**Supplemental Investigation
Summary Report**

**UOP Site
East Rutherford, NJ**

Revision 1

Re: UOP Superfund Site
East Rutherford, Bergen County

FIGURE 4-2B

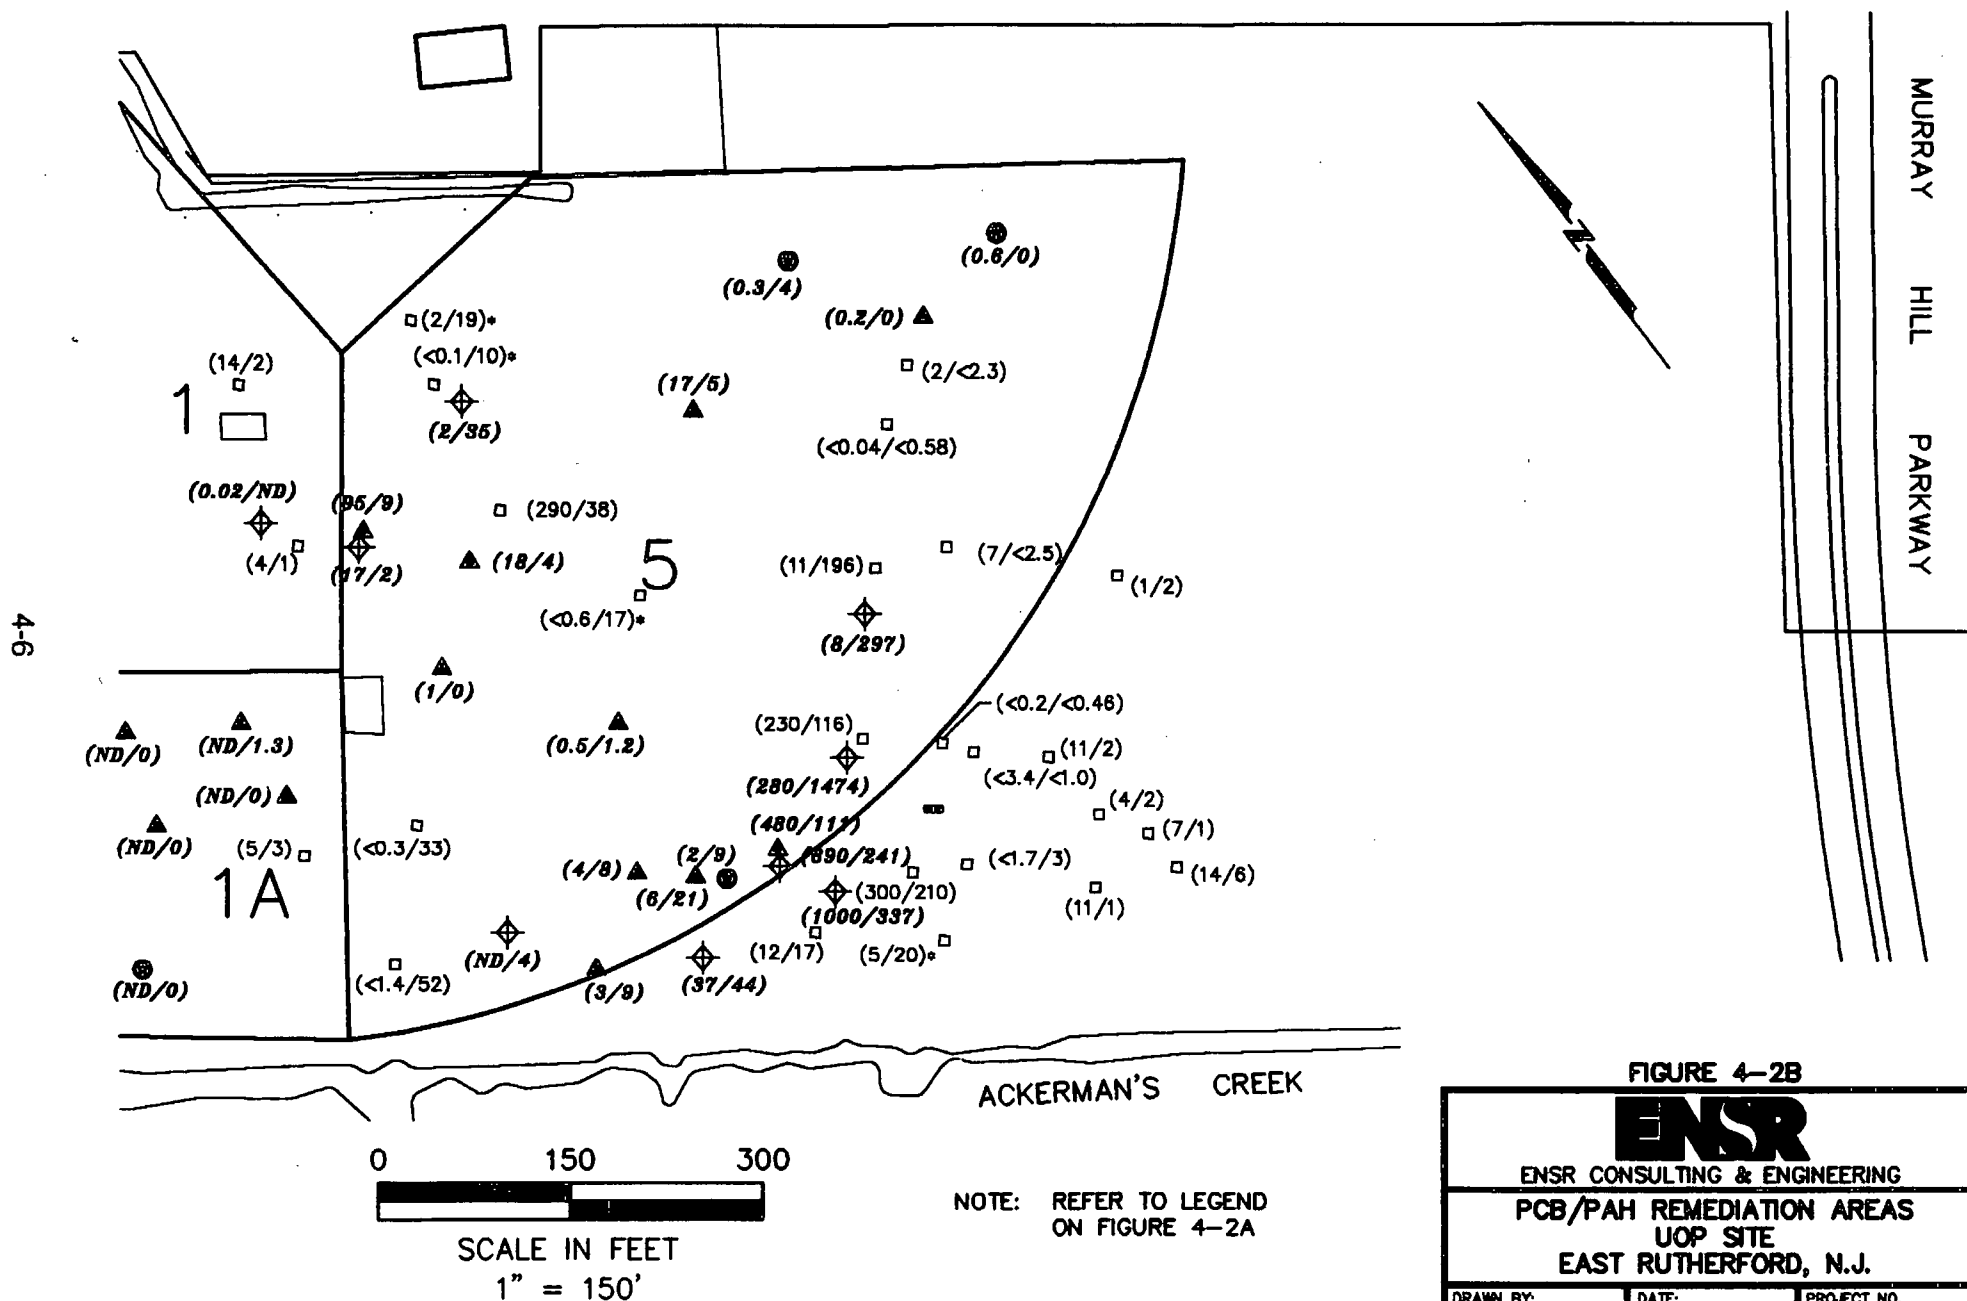
1. Replace the existing Figure 4-2B on page 4-7 of the document with the revised Figure 4-2B. The revised Figure 4-2B is provided in Attachment 3-C.
2. Replace the existing Figure 4-4 on page 4-10 of the document with the revised Figure 4-4. The revised Figure 4-2B is provided in Attachment 3-C.
3. The date (2/94) the revised figures were prepared is located in the center box in the lower left hand corner of each figure, and therefore, the switch can easily be double checked.

Figure 4-2A and 4-2B presents the remediation areas for surface soil containing PCB/cPAH, based on the combination of old and new data. The short dashed line on the figure shows the interface between the soil cover for the lead remediation area and the soil cover for the PCB/cPAH remediation area. Longer dashes show the outline of the lead area and the previous configuration of the PCB/cPAH remediation area, where it differs from the new area. Based on the remediation area identified and the depth of 2 feet, an estimated 8150 yd³ are targeted for treatment. Approximately 9600 cubic yards of soil from Area 1 and 2 will be excavated and placed under the cover in Area 5. The new cover area is an estimated 435,000 ft² or 10 acres. It should be noted that this new area is likely to incorporate a significant portion of wetlands. This report does not address any concerns raised by remediation in wetlands.
